#29/07-01A 10600 River Road  
(John McDonald House)

**HISTORIC PRESERVATION COMMISSION STAFF REPORT**

<b>Address:</b>	10600 River Road	<b>Meeting Date:</b>	08/15/01
<b>Applicant:</b>	William and Diana Conway	<b>Report Date:</b>	08/08/01
<b>Resource:</b>	<i>Master Plan</i> Site #29/07 <b>John McDonald House</b>	<b>Public Notice:</b>	08/01/01
<b>Review:</b>	HAWP	<b>Tax Credit:</b>	None
<b>Case Number:</b>	29/07-01A (REVISION)	<b>Staff:</b>	Perry Kephart Kapsch
<b>PROPOSAL:</b>	Driveway Relocation.		
<b>RECOMMEND:</b>	Approve.

**PROPOSAL:** Remove screened porch, construct 2-story side addition.

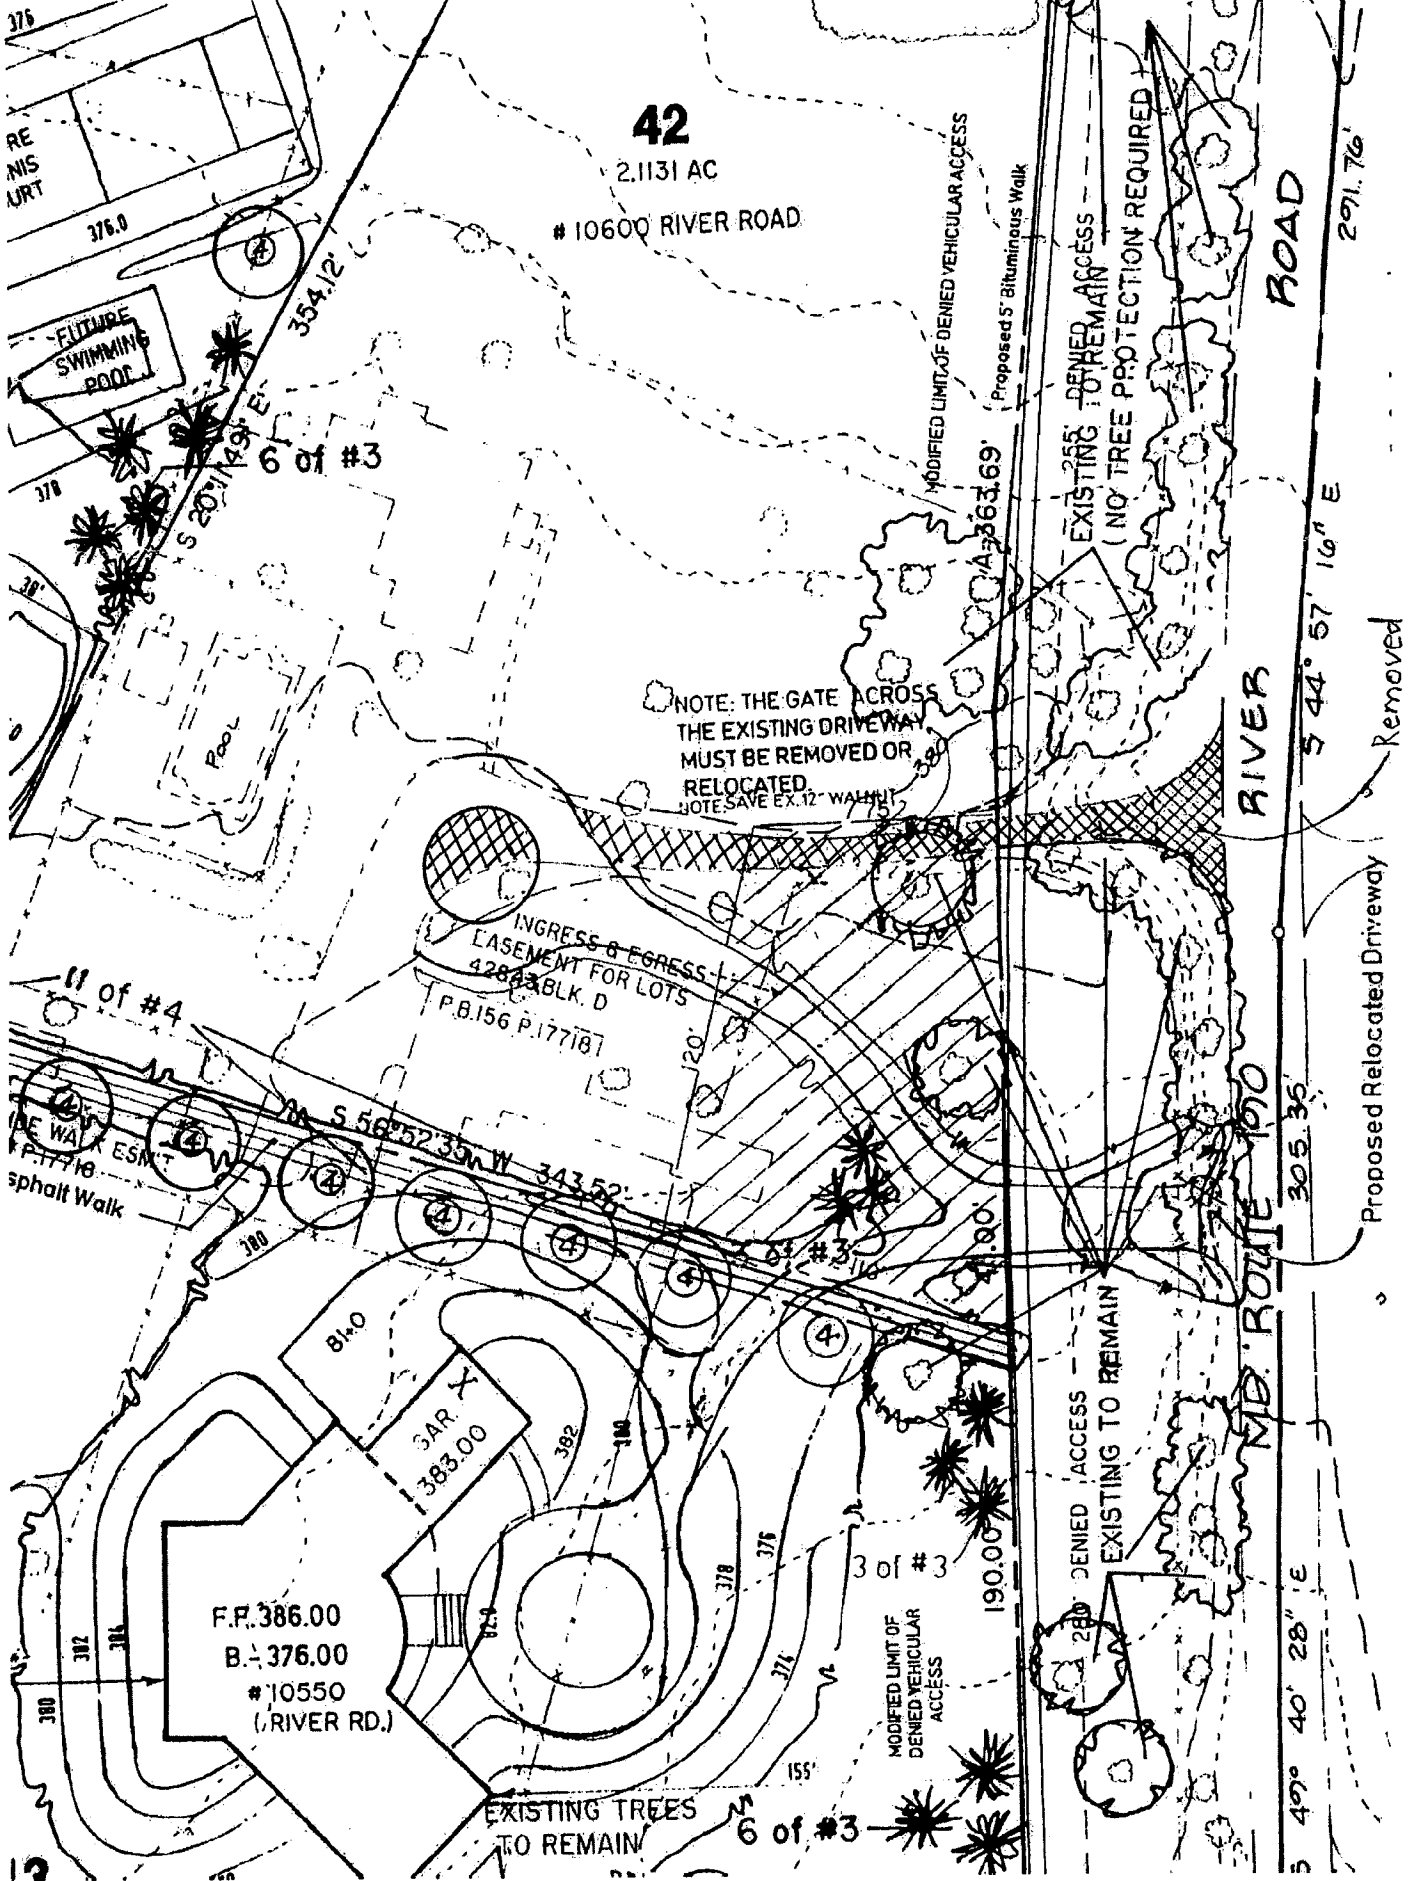
Enclosed is a drawing showing the circular driveway that we propose to construct at our home located at 10600 River Road. My understanding from our conversation is that you will present this drawing at the next HPC meeting as an amendment to our previously approved proposal to move the driveway closer to the shared property line with our neighbors, the Liu family, and that it won't be necessary to make a complete new HAWP application.

The only change being requested is the installation of a circular feature to the driveway. We previously applied for and received approval from the HPC to move the River Road entrance to the driveway as part of a HAWP to perform the major renovation on our home. I believe this was in 1995.

For purposes of background, the Lius have a right of access to their property through ours. The Lius find it desirable to move the driveway because it will shorten the length they have to drive to their house (on which construction will commence in a few months) and because they would otherwise have to make an awkward, sharp left turn off of our existing driveway. For our own part, we desire to move the driveway for enhanced privacy and so as not to lose the use of our land.

NORTH ELEVATION SCHEME 2

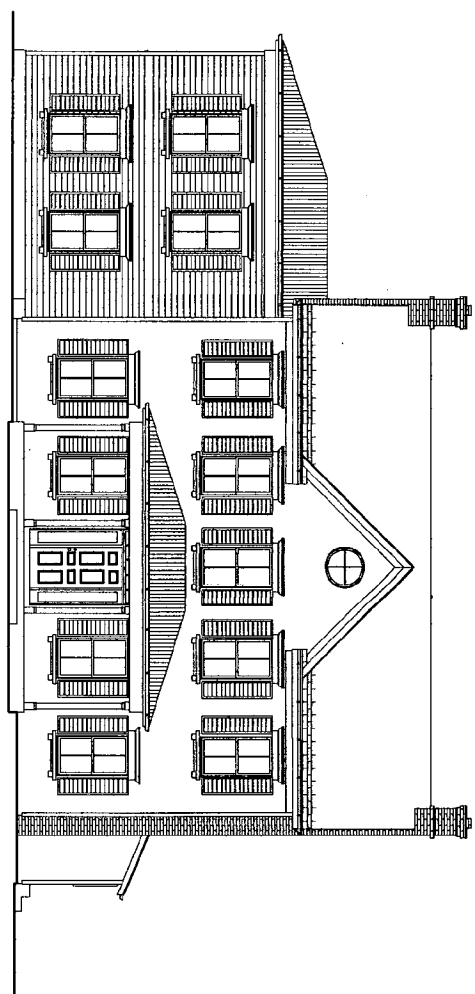
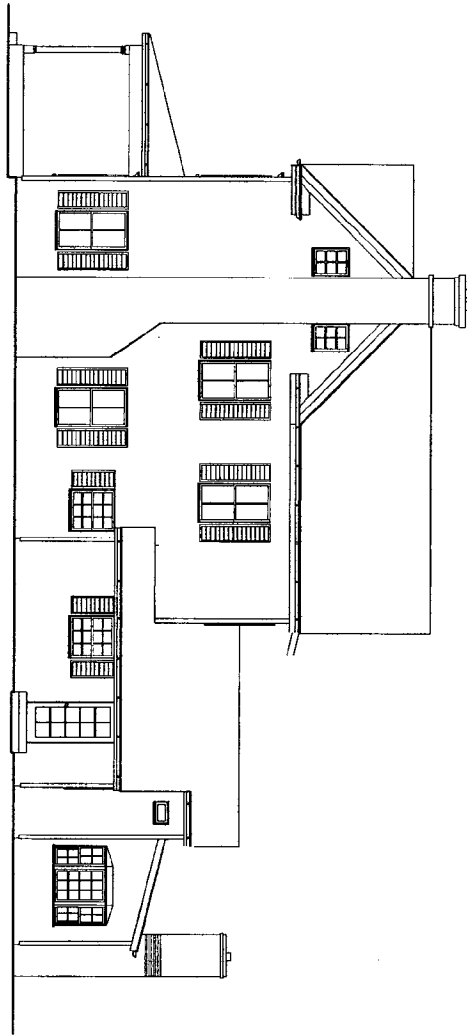
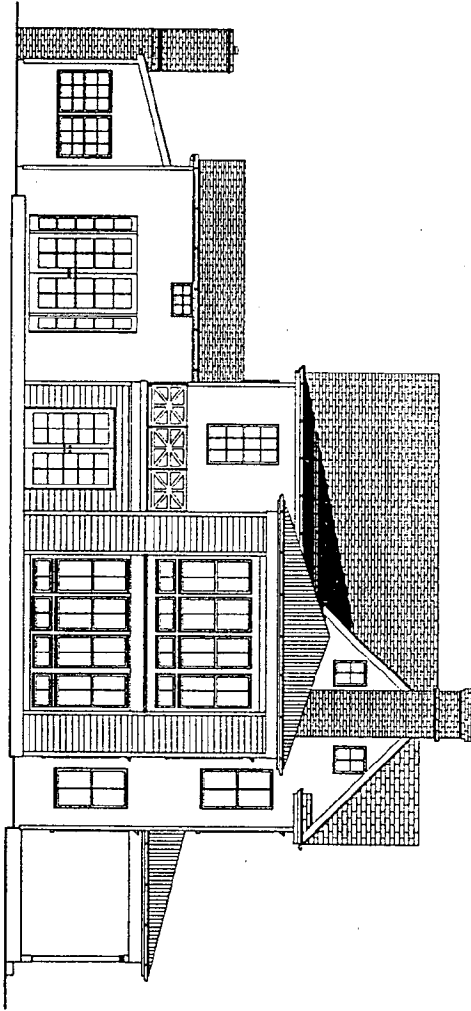
Scheme 2, in staff's opinion would use materials and a design that are in keeping with the style of the historic resource. The addition is offset from the principal façade. The proposed changes at the rear, including the bumpout, balcony and patio extension are out of view and can be approved. (5)

The use of a raised seam metal roof provides differentiation from the historic structure. Replication of the hipped roof on the screened porch may not be necessary, for the reasons stated above, but the use of a hipped roof is in keeping with the Italianate style of the house.

Overall, staff recommends that the applicant modify the project with particular attention to the Secretary of the Interior Standards #9 and #10:

NORTH ELEVATION SCHEME 1

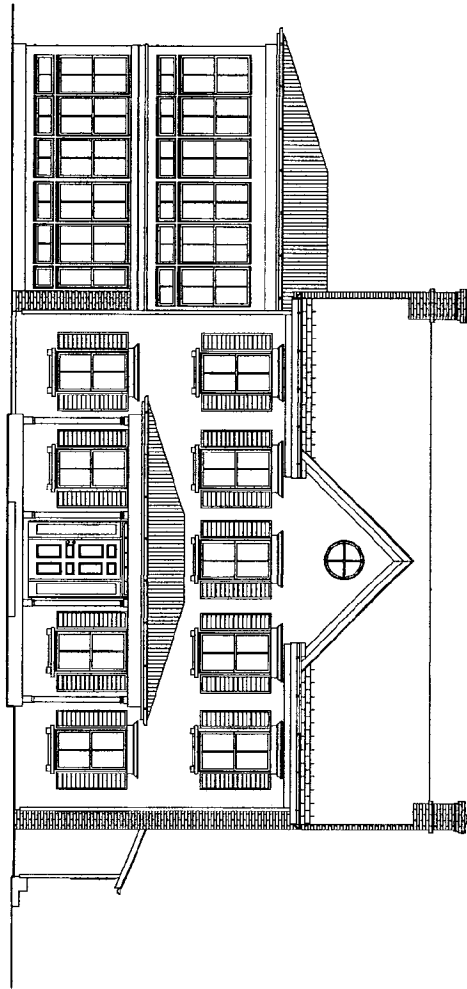
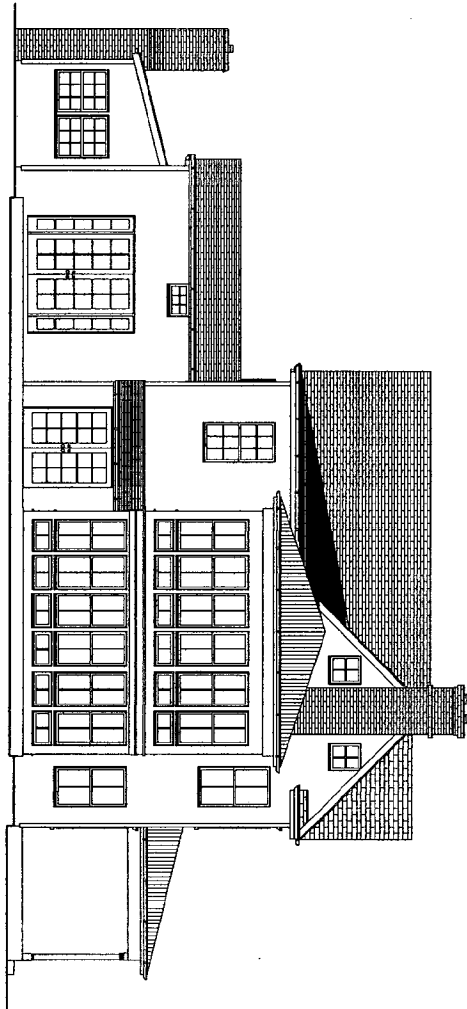
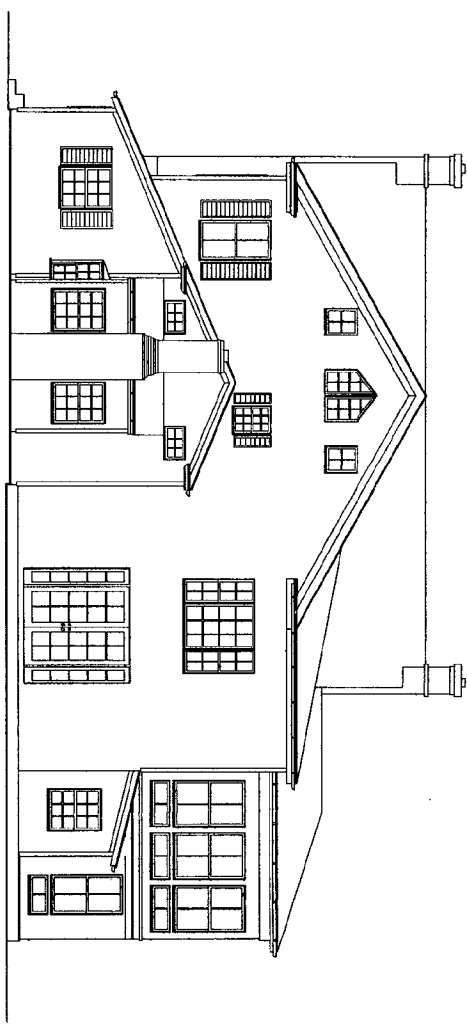
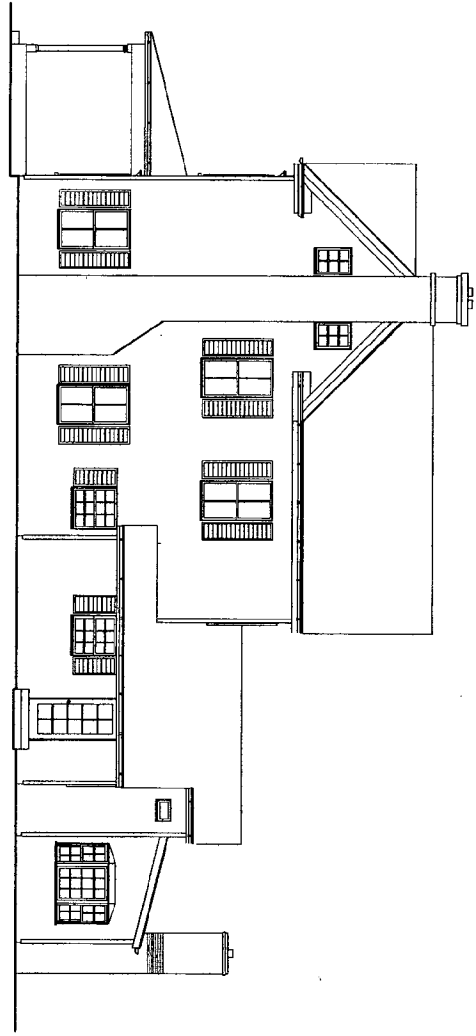
The applicants are proposing to replace the screened porch in order to have a playroom on the first floor and a home office adjacent to the master bedroom on the second level. They have presented two schemes for the design of the proposed addition. They have indicated a preference for Scheme 2 that shows a two-story two-bay addition clad in lapped wood siding. It has a rear connector (between the living room and the playroom) with a balcony on the second level. (4)

Overall, staff recommends that the applicant modify the project with particular attention to the Secretary of the Interior Standards #9 and #10:
